HISTORIC AND DESIGN REVIEW COMMISSION June 21, 2017

HDRC CASE NO: 2017-306 **ADDRESS:** 420 BROADWAY **LEGAL DESCRIPTION:** NCB 432 (SAN ANTONIO LIGHT), BLOCK 16 LOT 14 **ZONING:** FBZ T6-1,HS **CITY COUNCIL DIST.:** 1 LANDMARK: San Antonio Light Building **APPLICANT:** Adam Reed/Ford, Powell & Carson **OWNER:** Graystreet, 420 Broadway LLC Rehabilitation, exterior modifications and a connection addition **TYPE OF WORK:**

The applicant is requesting conceptual approval to:

EARLY CONCEPT SKETCH

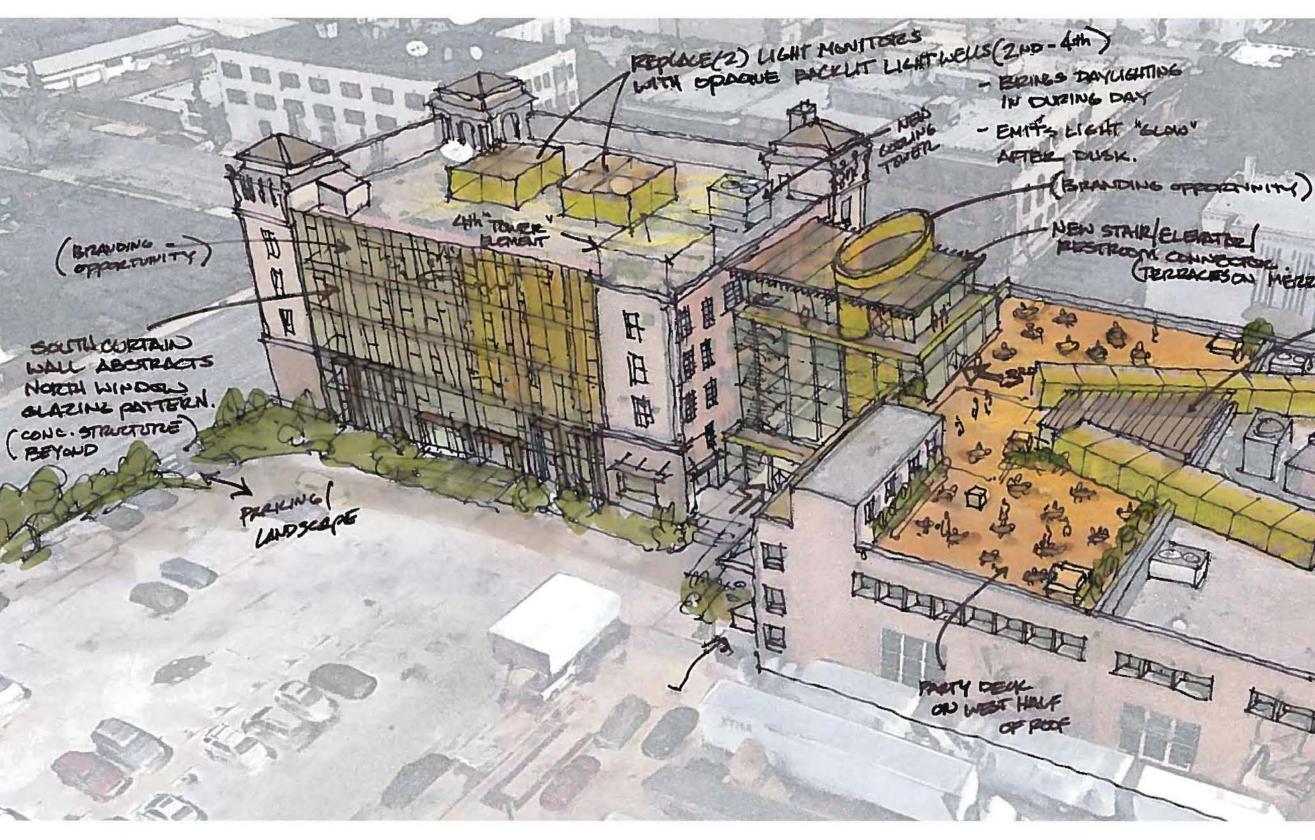
- e. CONNECTOR ADDITION- The applicant has noted a both a glass curtain wall system and a solid paneling system to connect the Light Building to the Print Building. As currently proposed, staff finds the solid paneling system to add visual weight and mass to the proposed structure. Staff finds that the applicant should reduce the amount of solid cladding and introduce more glazing to be consistent with the conceptual sketch that is included in the application documents.

- i. Archaeology Archaeological investigations are required. The archaeological scope of work should be submitted to the OHP archaeologists for review and approval prior to beginning field efforts. The development project shall comply with all federal, state, and local laws, rules, and regulations regarding archaeology.
- ii. That the applicant remove the proposed corner tower and maintain the existing last column bay as is as noted in finding h.
- iii. That the applicant remove the proposed solid cladding material proposed on the connector addition and incorporate glazing as noted in the early conceptual sketch included in the application documents as noted in finding e.

SOUTH ELEVATION SHOWING VERTICAL CONNECTOR & CURTAINWALL

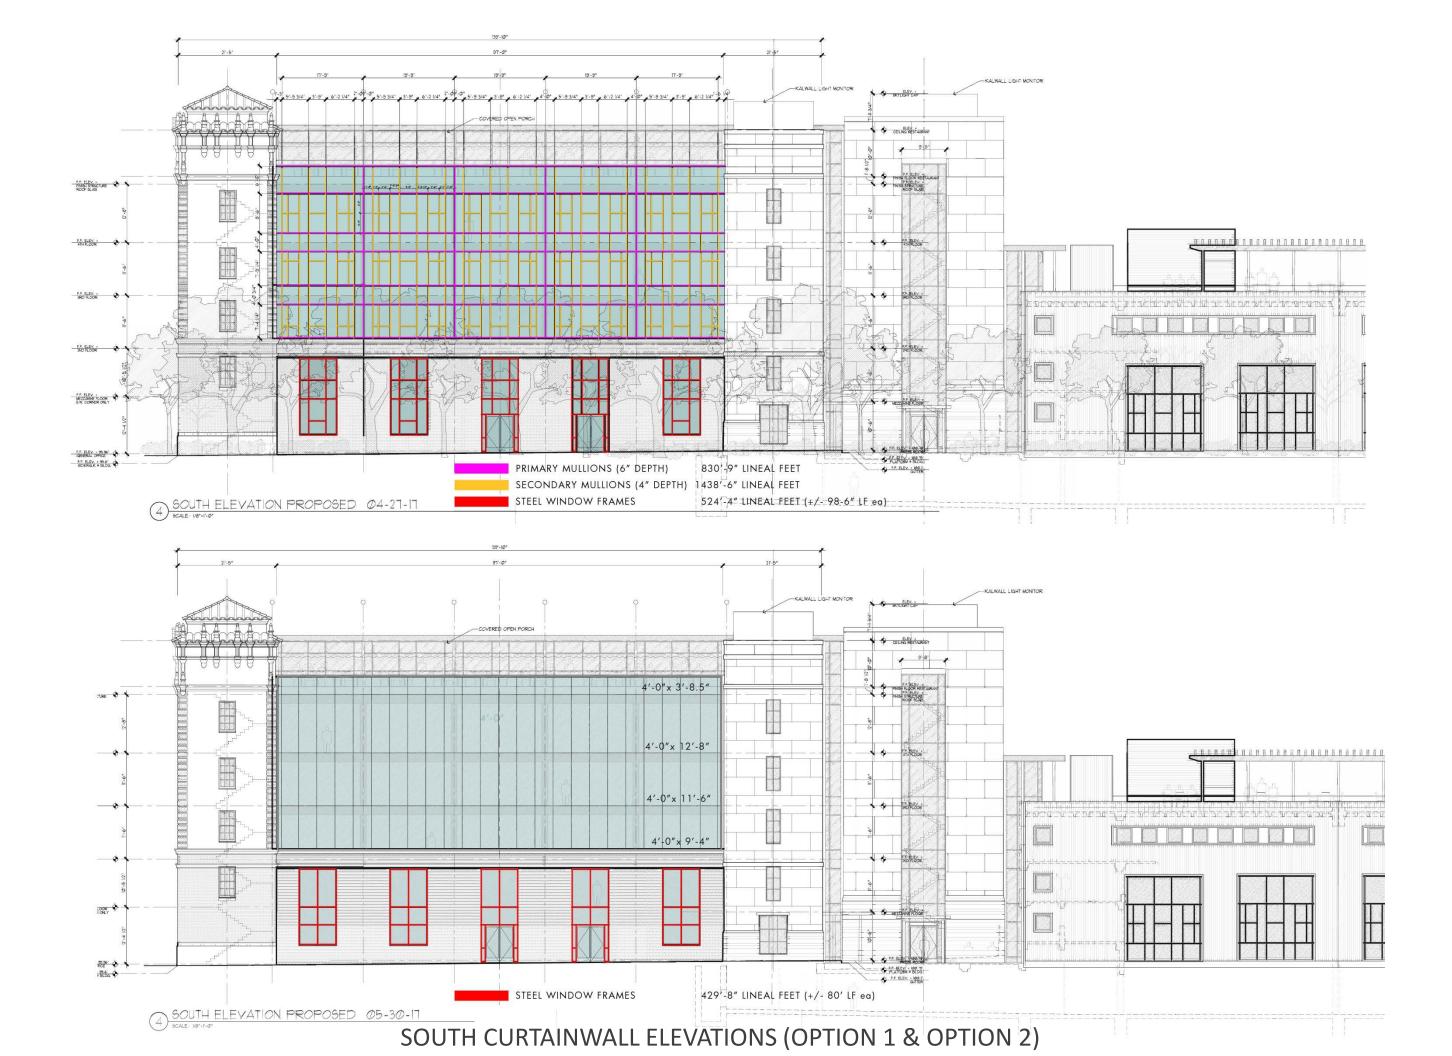
- f. CURTAIN WALL MODIFICATION The southern façade of the Light Building is currently void of ornamentation of façade openings. The façade features brick from the street level to the top of the mezzanine level and then features stucco to the roof parapet. The applicant has proposed to modify this wall and install a glass curtain wall system. The applicant has proposed to maintain brick from the street level to the top of the mezzanine level and to create façade openings within this brick. The glass curtain wall system will span from the top of the brick to the top of the roof's parapet wall.

- g. CORNER TOWERS The applicant has proposed to maintain each corner tower; however, the applicant has proposed to install window openings on the southern façade of the tower on the southwest corner of the building. Staff finds this installation appropriate.

- h. CORNER TOWER ADDITION The only corner of the structure that does not feature a corner tower is the southeast corner. The applicant has proposed to construct a tower to be a contemporary interpretation of the original corner towers. While the location and general height will be consistent with the originals, staff finds the installation of the proposed corner tower adds additional massing to the rear of the historic structure that distracts

from the historic facades. Staff finds that the applicant should remove the proposed new corner tower and leave the last column bay as it currently exists; however, staff finds that the inclusion of the proposed roof level light element is appropriate.

HISTORIC WINDOW SURVEY AND INVENTORY

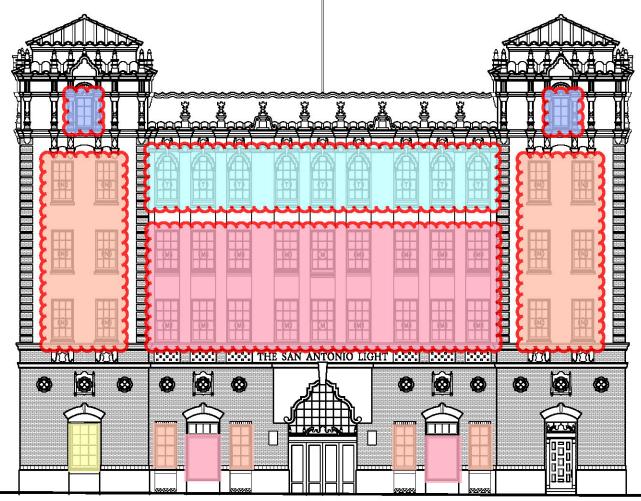
- c. WINDOW REPLACEMENT The current windows in the Light Building are aluminum and are not the original windows. The current windows feature a one over one profile. The original windows featured a six over six profile. The applicant has proposed to install new, six over six windows that match the profile of the original. Staff finds this replacement appropriate.
